NOTICE OF PROPOSED DEVELOPMENT

SITE: 4 Lateena Street, Dodges Ferry

SECONDARY RESIDENCE

ONSITE WASTEWATER SYSTEM DESIGN – 4 Lateena Street, Dodges Ferry – RESPONSE TO COUNCIL RFI

DRAWING
SEWER DRAINAGE LAYOUT

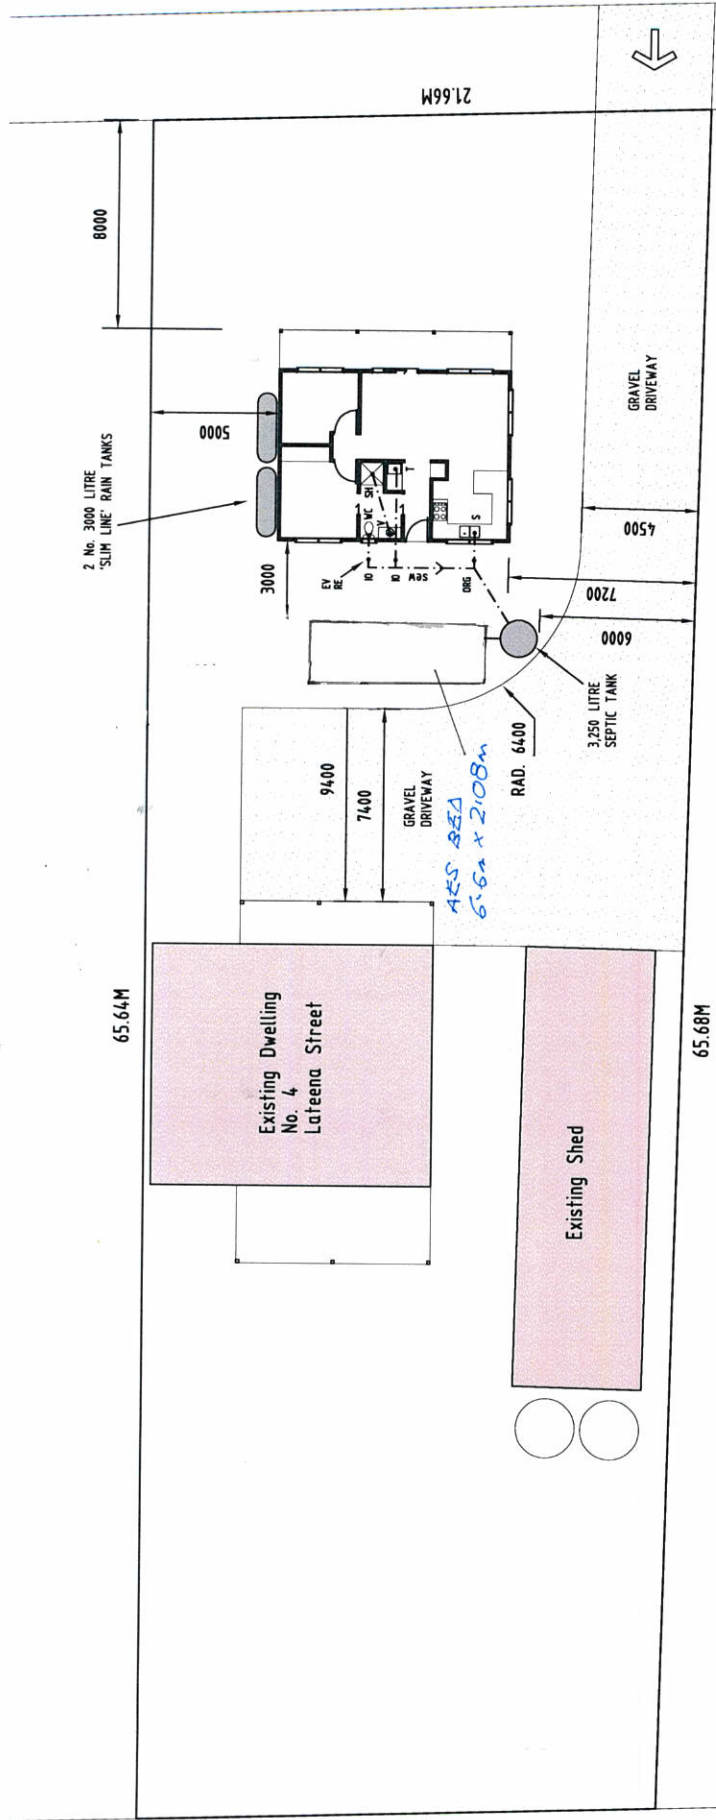
1. Response to 10.4 Development Standards – Specially 10.4.3 - **Not Satisfied, please provide why the main dwelling & secondary residence cannot share the wastewater system**

1. The decision to design a second wastewater system was taken after consultation with Greg Robertson (Senior EHO). The proposed new ancillary dwelling, sited between the main residence and Lateena Street cannot be connected to the main residence's wastewater system due to;
 - It is not 'hydraulically feasible' to connect to the main residence's wastewater system.
 - The main residence's wastewater system is not sized adequately to accept wastewater from an additional 4 occupants.
 - The main residence's wastewater system is wholly contained on the northern portion of the site.

- For the two residences to utilise a common wastewater system it would be necessary to install a completely new, larger system. This would require decommissioning the current wastewater system (no part could be reused). It would be necessary to install a relatively complex system with a macerating transfer pump to get fall to where a common system could be sited. This was considered unnecessary as the system is in good working order, and is sited on a dry, pure, deep sand site with extremely high permeability.

DRAWING **SITE PLAN /
 STORMWATER LAYOUT**
 CLIENT **R. & G. JOHNSON**

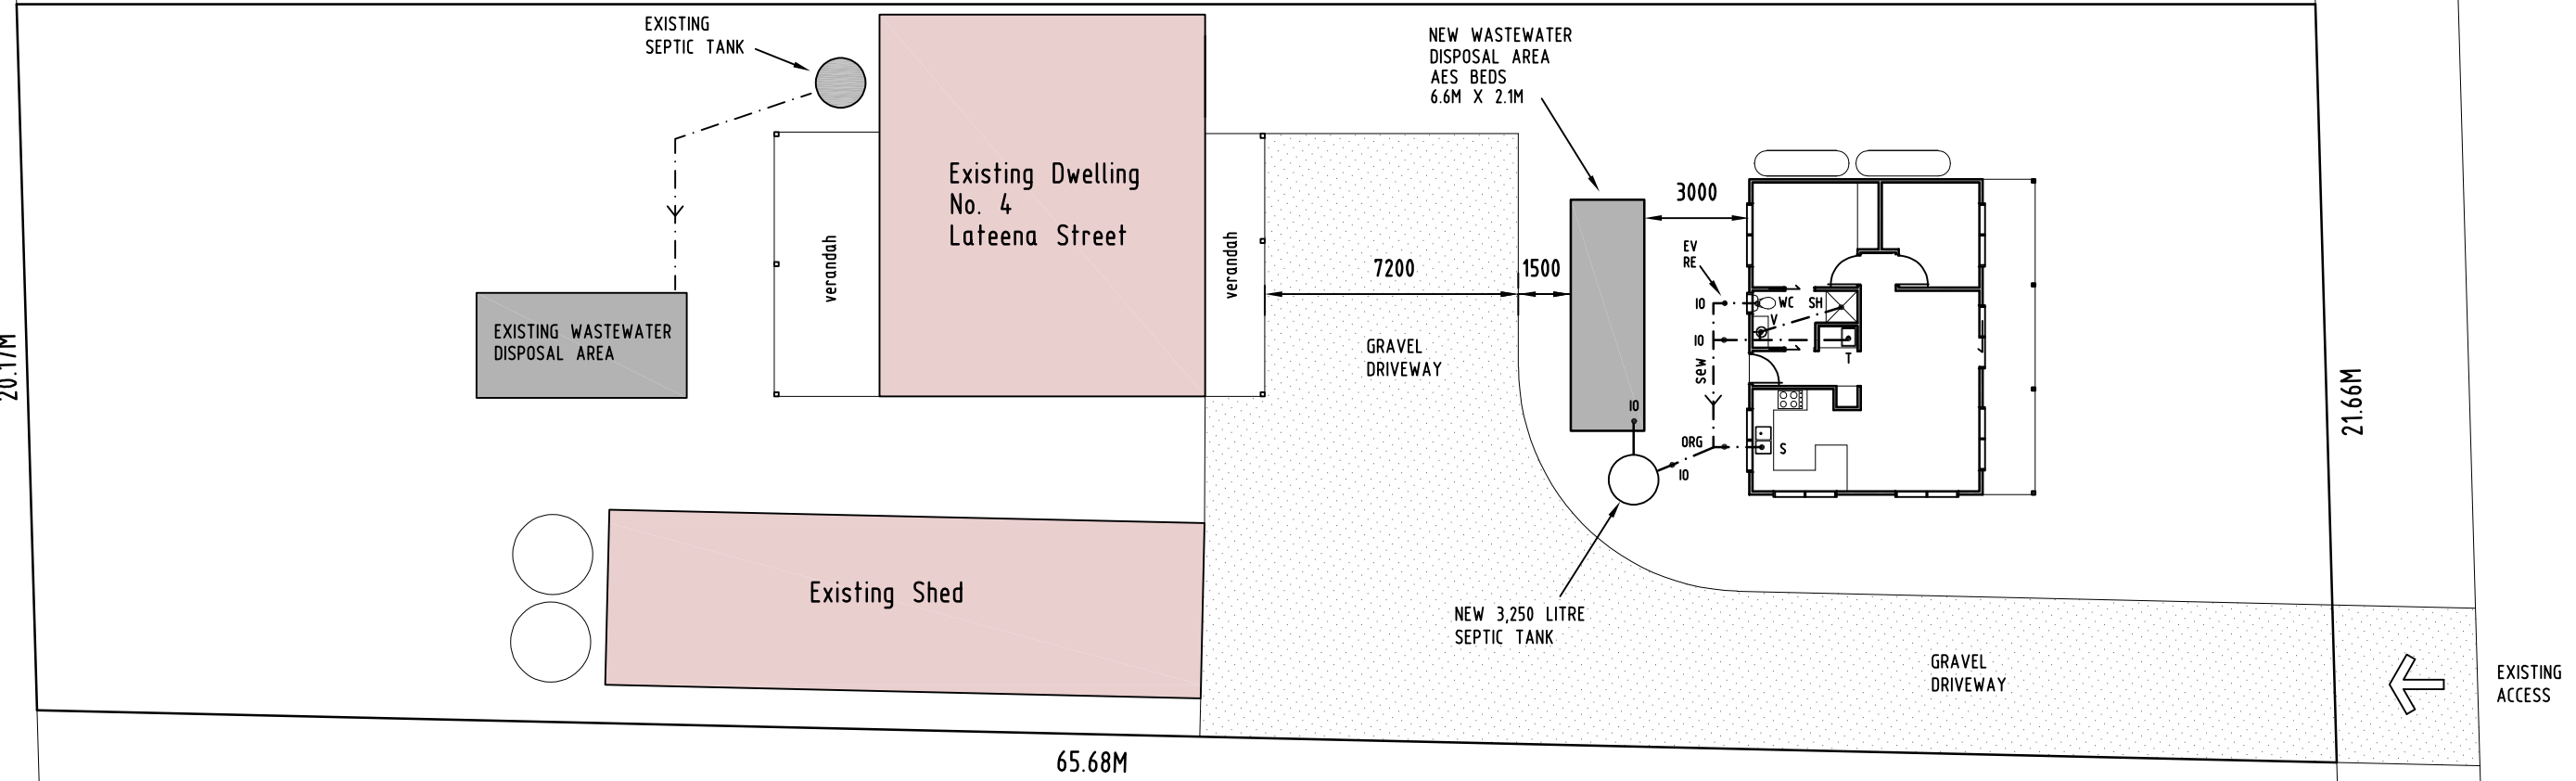
4. Provide a Site & Soil Evaluation Report in accordance with AS/NZS 1547-2012 detailing the site and soil conditions and the suitability for onsite wastewater disposal. The Report should be prepared by a suitably qualified person such as an Engineer, Geologist, Environmental Health Officer or a Soil Scientist.
- **Not Satisfied, report provided demonstrates that there is sufficient area for wastewater land application for the ancillary dwelling, but does not demonstrate compliance with SAP SOR 2.7.1 P1 as the report does not comment on whether the whole site has sufficient area for wastewater land application.**

4. There is ample available land to the north of the main residence for a reserve wastewater Land Application Area. The area is underlain by deep, dry sand. Over 130m² of vacant, suitable land is available between the main residence and northern property boundary (Figure 1). If the current absorption trenches need to be replaced in the future an area of only 20m² would be required (within the above mentioned 130m²) if a new Advanced Enviro-Septic bed was installed (deep, dry sand).
